SAFETY EVALUATION
PILGRIM NUCLEAR POWER STATION

Initiator	Dept.	Division	Document No.	Calc. No.	System Name
P.D. Harizi P.J. Doody	NESG	Mech. Eng. S&SA	PDC 83-62	M-662	Drywell

Description of Proposed change, test, or experiment: Replace all piping thermal insulation in the drywell with Owens-Corning NUKON fiberglass blanket insulation.

This Safety Evaluation supersedes SE No. 1638, Rev. 1 dated 8-6-84.

Figure 14.5-13. NPSH Available Following Design Basis LOCA

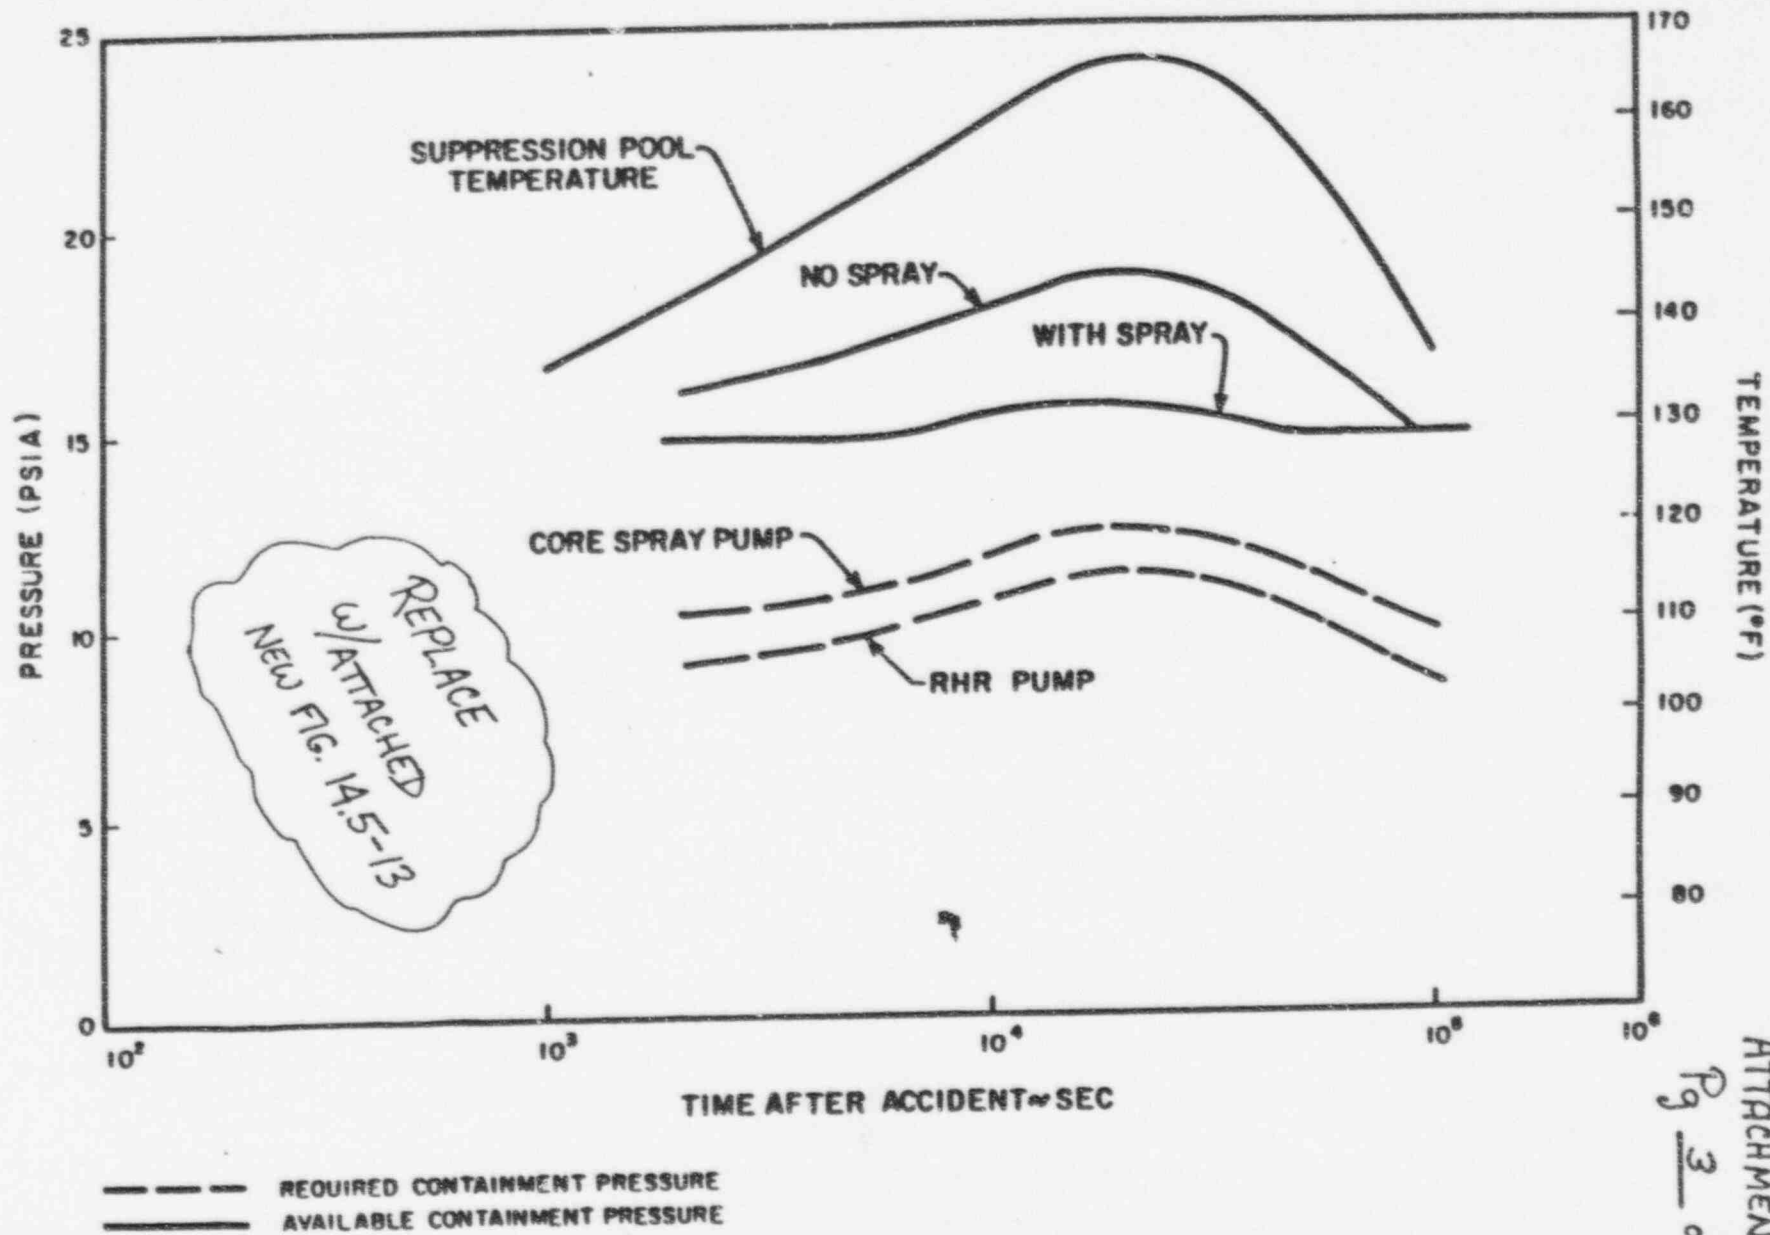
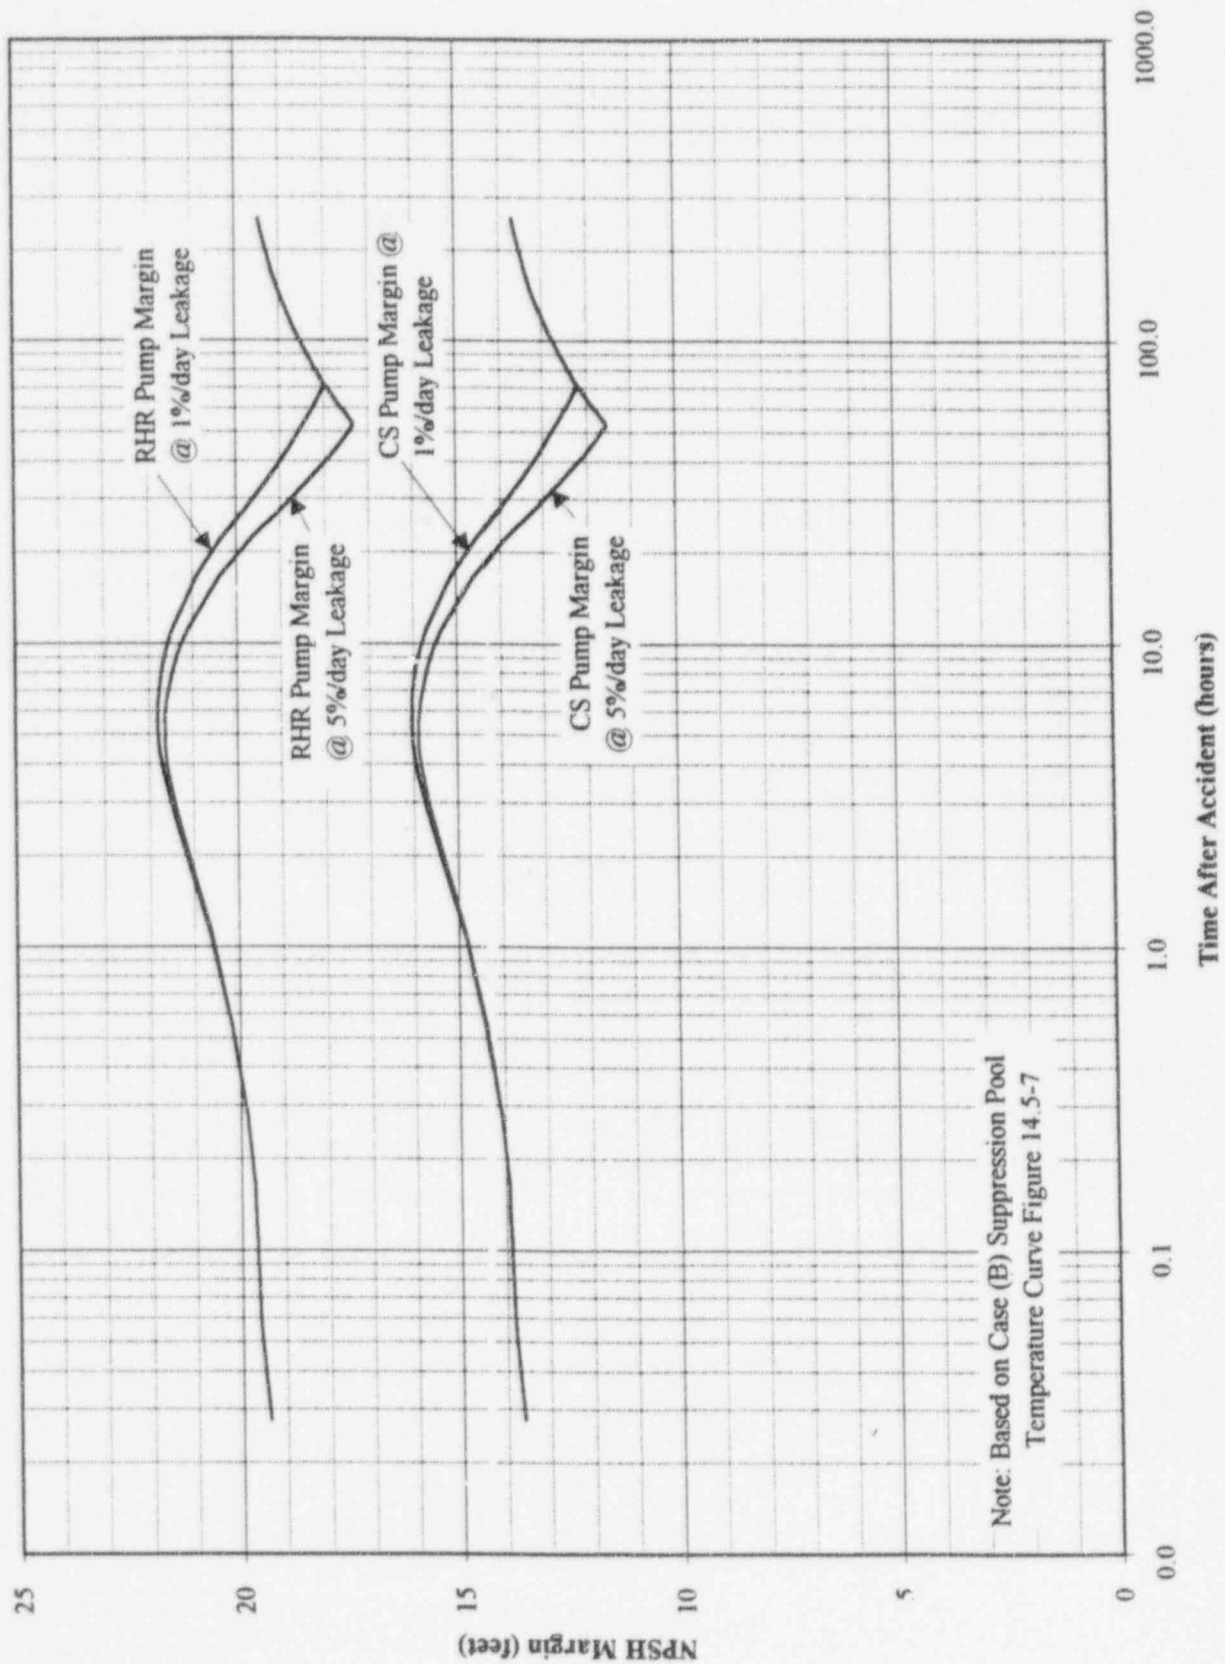
Included with this Safety Evaluation is a revision to the FSAR to replace Figures 14.5-9, 10, and 13 with updated figures generated from Calculation M-662 [Ref. 9]. The new figures are based on updated values for pump NPSHR, suction line loss, containment initial conditions, and the application of leakage calculated as a function of pressure rather than a flat mass reduction taken at initial conditions. The new figures also show that containment pressure does not continue to decrease below atmospheric pressure since this is not possible but was depicted as such on the original FSAR figures. In addition, the design value for containment leakage is now included as 1% per day at a reference pressure of 45 psig to be consistent with Tech Spec 4.7.A.2, and at 5% per day as before.

The original FSAR Figure 14.5-13 included a curve showing the effect of continuous containment spray on available containment pressure for a DBA LOCA. As shown for the spray case, the containment pressure is at or above atmospheric pressure while the pressure required to meet NPSH requirements is always less than atmospheric pressure, hence NPSH available exceeds NPSH required during continuous spray for the nominal design case. The original FSAR Figure 14.5-13 does not reflect the drywell spray reduction implemented via PDC86-52A or the potential effects of fibrous debris on available NPSH.

Figure 14.5-13 NPSH Margin for RHR and Core Spray Pumps After a DBA-LOCA
